AIR RESOURCES BOARD

Final Statement of Reasons for Rulemaking,

Including Summary of Comments and Agency Response

OF THE LOW CARBON FUEL STANDARD

Figure 4: Incentive value provided by the LCFS. Range represents $50 to $150 per MT CO2e reduction.

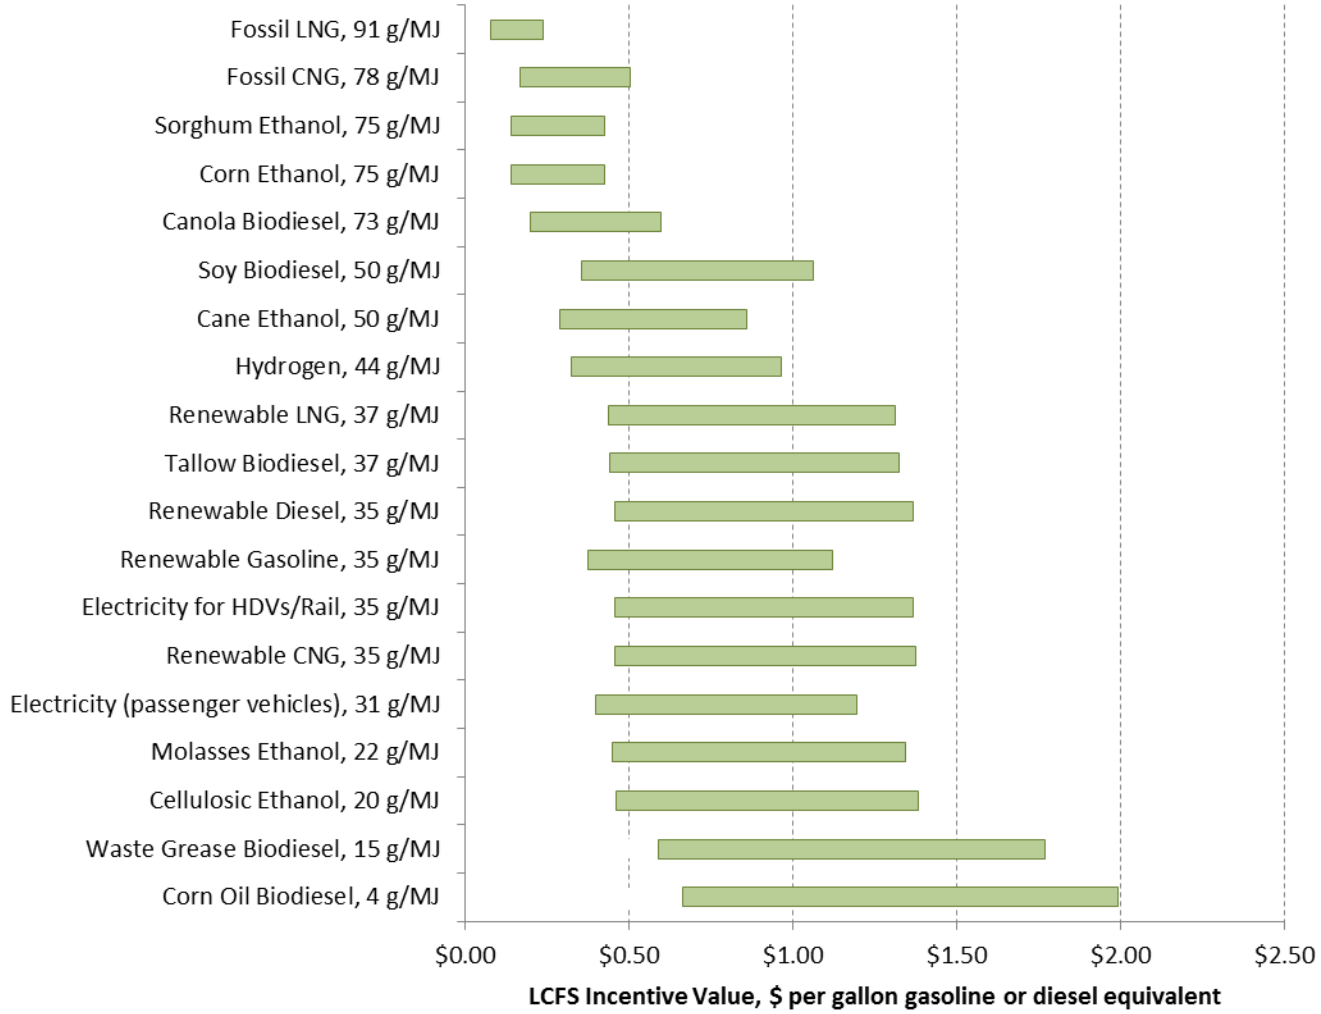
As shown in Figure 4, the Reference Case of $100 per MT carbon dioxide reduction, translates into $0.92/gallon for cellulosic ethanol. Theoretically, as long as the LCFS credit value together with the associated cellulosic RIN prices exceed transportation costs, we should see producers ramping up capacity and selling into California as well as California producers expanding and increasing production.

Figure 8. Change in Arable Land Plus Permanent Crops: 2004–2006 to 2010–2012

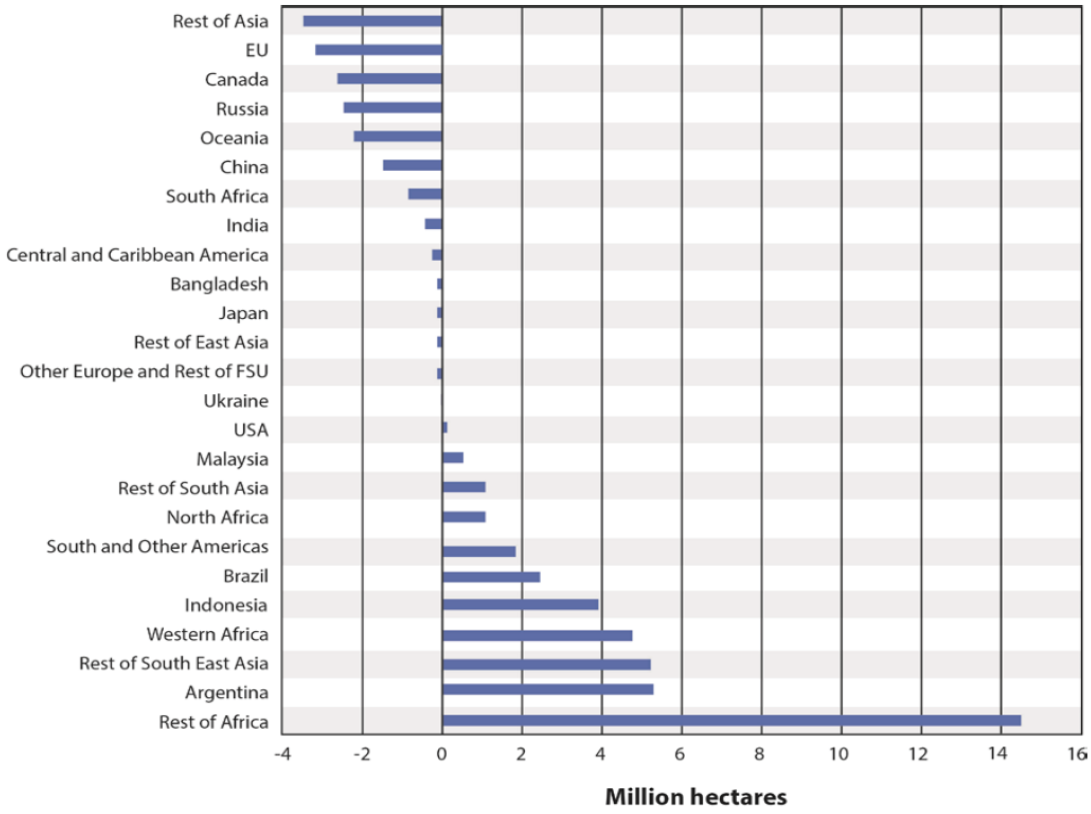
> The countries in Figure 8 that either had negligible or negative extensive land use changes **should be presumed to not have converted pasture or forest to crops in response to biofuel-induced higher prices**. Rather, the presumption should be that **any predicted change in land used in agriculture came from cropland that did not go out of production**.[7]

Figure 8 from Babcock & Iqbal is embedded below. Note that many countries and regions for which CARB's latest GTAP analysis predicts extensive change from forest and grassland to crops actually showed cropland losses or no change. This includes Canada, EU, Japan, China, India, Russia, the U.S., and Oceania. Further, the amount of corn ethanol-induced conversion of

forest and grassland in the U.S. predicted by CARB's GTAP model is two to four times larger than the actual extensive land use change in the U.S. driven by ***all factors in aggregate***.

As stated in the Babcock & Iqbal paper, CARB should not presume that higher crop prices have caused conversion of forest and grassland to crops in countries and regions where cropland has actually decreased over the past 10 years. Thus, we believe CARB should calibrate its GTAP model to disallow forest and grassland conversion in AEZs and regions for which empirical data show forest or grassland expansion and/or cropland contraction. This can be easily accomplished by excluding GTAP predicted land conversions for the countries in Figure 8 of Babcock & Iqbal that show negative extensive change (i.e., loss of cropland). A more detailed method for accomplishing this calibration is available in comments submitted to CARB by Air Improvement Resource on Dec. 4, 2014.[9]

For the countries in Figure 8 that *do* show extensive land use change over the past 10 years, CARB can continue to rely on GTAP predictions, but should also conduct more intensive research to better understand the precipitating causes of land conversions at the extensive margin in those countries. For example, while Sub-Saharan Africa (excluding South Africa) shows significant extensive change over the past decade, it is likely unrelated to biofuels expansion in the U.S. According to Babcock & Iqbal, "The extent to which extensive expansion in African countries was caused by high world prices is likely small for the simple reason that higher world prices were not transmitted to growers in many African countries."[10]

Figure 8. Change in Arable Land Plus Permanent Crops: 2004–2006 to 2010–2012

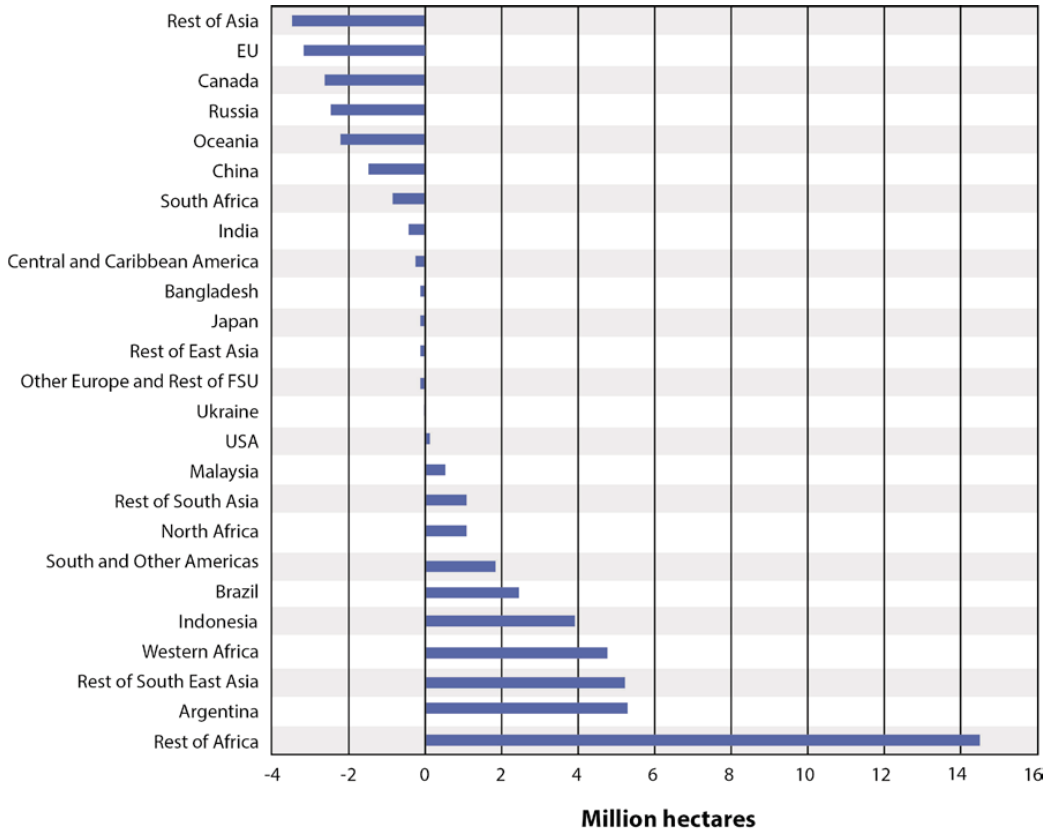
The implications of Figure 8 are strikingly different than Figure 2. Furthermore the Figure 8 data is much more consistent with the country-specific data in China, India, Brazil, Indonesia, and Africa. Figure 8 data suggest that the net change in global cropland over this period is 24 million hectares. African countries increased cropland by 20 million hectares. Other countries with more than a million-hectare increase include Argentina, Indonesia, Brazil, Rest of Southeast Asia, Rest of South Asia, and South and Other Americas. Countries with significant reductions in cropland include the EU, Canada, China, Russia, and South Africa.

The countries in Figure 8 that either had negligible or negative extensive land use changes should be presumed to not have converted pasture or forest to crops in response to biofuel-induced higher prices. Rather, the presumption should be that any predicted change in land used in agriculture came from cropland that did not go out of production. From Figure 11 this would include Canada, the EU, Russia, the Ukraine, and India.
